# *City of Afton*

## **Natural Resources and Groundwater Committee (NRGC)**

**Agenda  
Tuesday, March 7, 2017  
5:00 PM**

Re: Will Carlson Sketch Plan for a Preservation and Land Conservation Development Subdivision for 218 acres of Land Located on 60<sup>th</sup> Street West of Trading Post Trail.

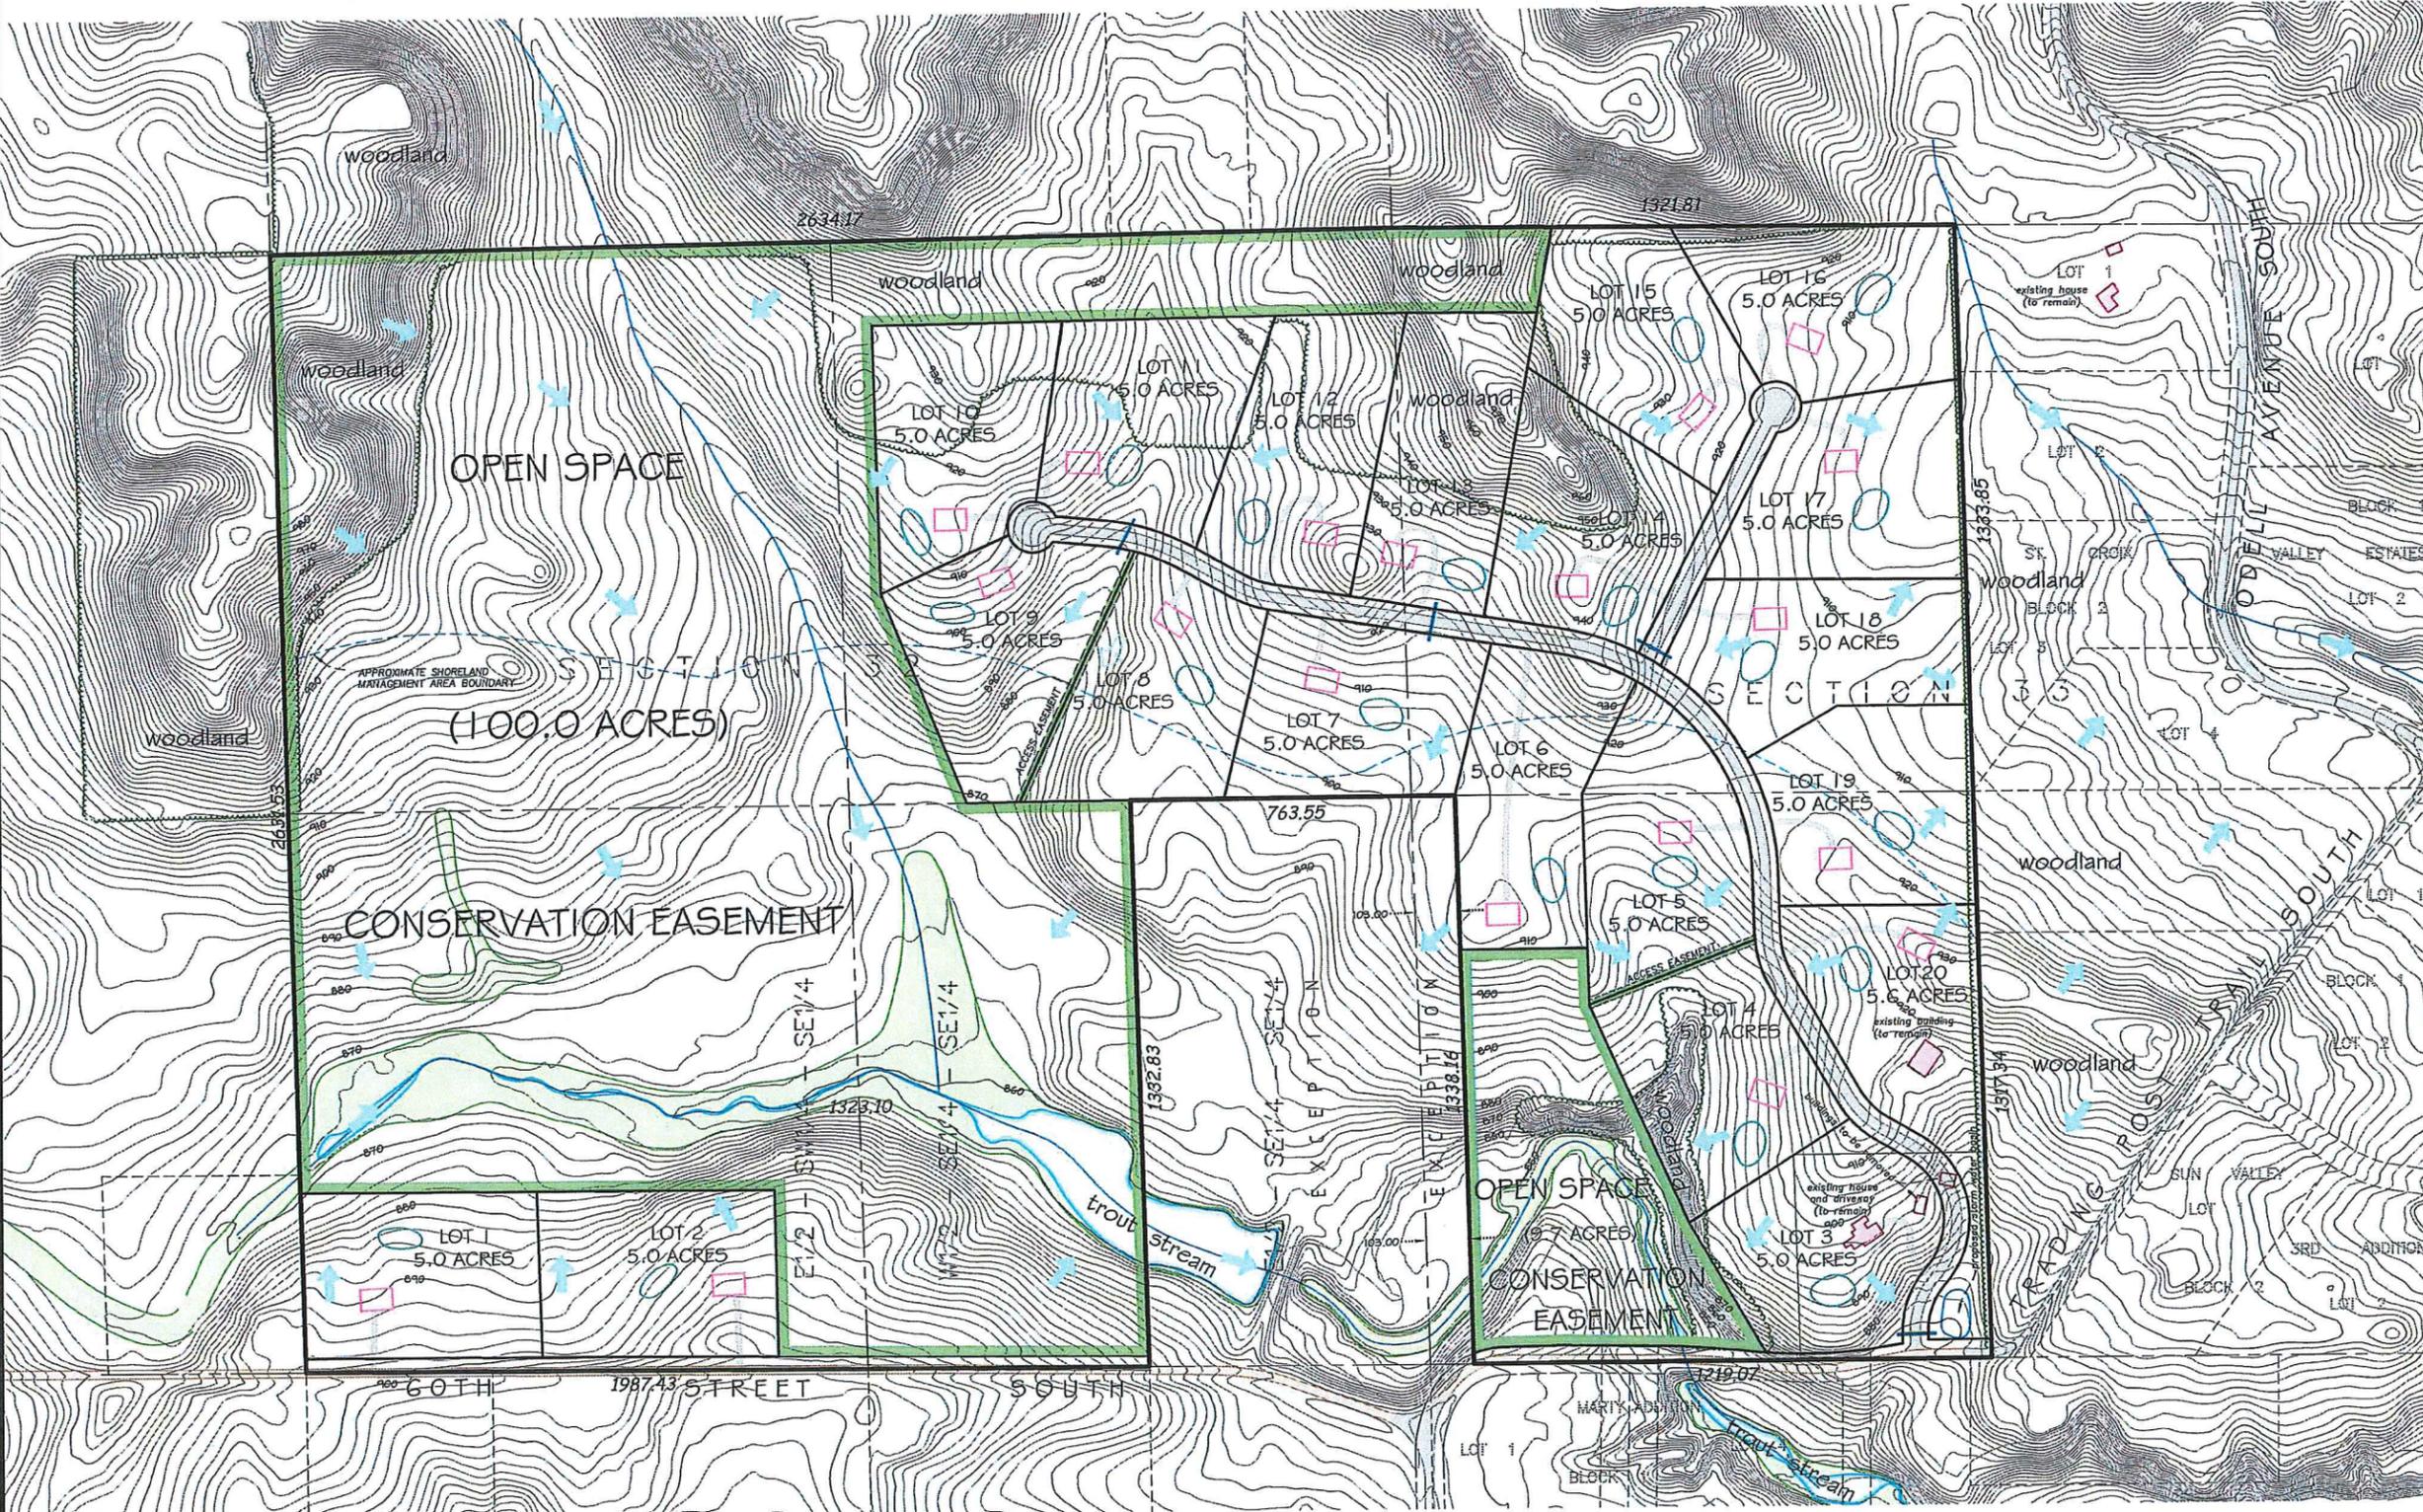
- May asked what the **distance is between closest lot line and the creek**, along lots 1, 2 and creek (western edge). Bush not sure due to scale of map on reduced plat copy. He says 75 ft. is required from ordinary high water mark.

- Winsor asked that the **Conservancy Overlay District and Shoreland Management District be clearly overlaid** on the next plat, as requested at the December meeting. Bush said it's hard to identify specifically where they lie, but he will do that.

- Although lot 3 has been removed, Winsor has continued concerns about the steep slopes (above 18%) on what are now lots 2, 4, 13, 14, and related soil erosion and water runoff, as earmarked in Shoreland Management districts and less specifically in Conservancy overlay districts, in which these lots lie. Bush replies that each lot has the requisite 2.5 acres of buildable more level space.

\*Remove Lots 1, 2, and 3 due to concerns about erosion into trout stream and river nutrient contamination. These appear to lie in the Conservancy Overlay District, and in part, in the Shoreland District.

\*Lots 4 & 5: Add parts with slopes above 13% to the 10-acre adjacent Open Space immediately to the West, and the remainder comprises one lot instead of two, if eligible per Afton zoning laws. These appear to lie in the Conservancy Overlay District, and in part, in the Shoreland District.

\*Lots 9 and 10: Append to adjacent Open Space Conservation Easement for reasons of slopes above 13% grade.

\*Lots 14, 15 and 16: Add those lot portions with slopes exceeding 13% to the adjacent Open Space to the North. Remaining portion comprises one lot, or whatever the remaining less steep landscape represents.

- Without modifications, alignment of the PLCD road access point on 60th street would present hazards due to existing sight line restrictions and reduced right of way on 60th Street near the intersection of Trading Post. In addition, 60th Street is currently gravel and subject to continual erosion around this access point. Preliminary calculations indicate that the PLCD would add 200 car trips per day to a road already inadequate. Further study is necessary to analyze and impose mitigation measures to address safety issues at the PLCD road access point. A better access point would be located farther west where 60<sup>th</sup> Street straightens out; access could be from PLCD Lot 1 or 2.

- PLCD Lots 15, 16, 17, 18, 19, and 20 abut or are adjacent to existing lots/homes on the eastern boundary of the PLCD. Drainage from these PLCD lots flows towards these existing homes. Stormwater runoff from the Carlson property is currently a problem for these existing homes during heavy rain events with large amounts of water flowing from the Carlson property through these adjacent properties. The addition of more impervious surface and turf associated with the PLCD will exacerbate the existing drainage problem and is not addressed with on-site containment as required in Sec. 12.217 and 12.409.

1. Realign road access to the PLCD from 60<sup>th</sup> street farther away from the eastern edge of the PLCD property line and closer to the western portion of current PLCD Lot 3 and 4. Relocation of the access road farther west along 60<sup>th</sup> where it straightens out should be strongly considered from a safety standpoint. Access onto 60<sup>th</sup> could be from PLCD Lots 1 or 2.

8. In lieu of the park dedication fee, the City shall take acreage located in the currently identified 9.7-acre Open Space Conservation Easement (OSCE) that currently abuts PLCD Lots 3, 4, and 5 to provide public access to this section of Trout Brook. This area contains some of the most scenic parts of Trout Brook and has high value to the public for passive use open space.

9. The City should also consider taking PLCD Lot 2 in lieu of part of the park dedication fee. The developer should build a parking area at this location and a public access way on the western portion of this Lot with a pedestrian bridge/boardwalk across the wetlands adjacent to Trout Brook to provide access to the OSCE just north of this site.

10. A study shall be conducted, and mitigation plan executed as necessary, to address the adverse impact of surface water runoff toward the NE branch of Trout Brook originating from the area of PLCD lots 15, 16, 17, 18, 19 and 20.
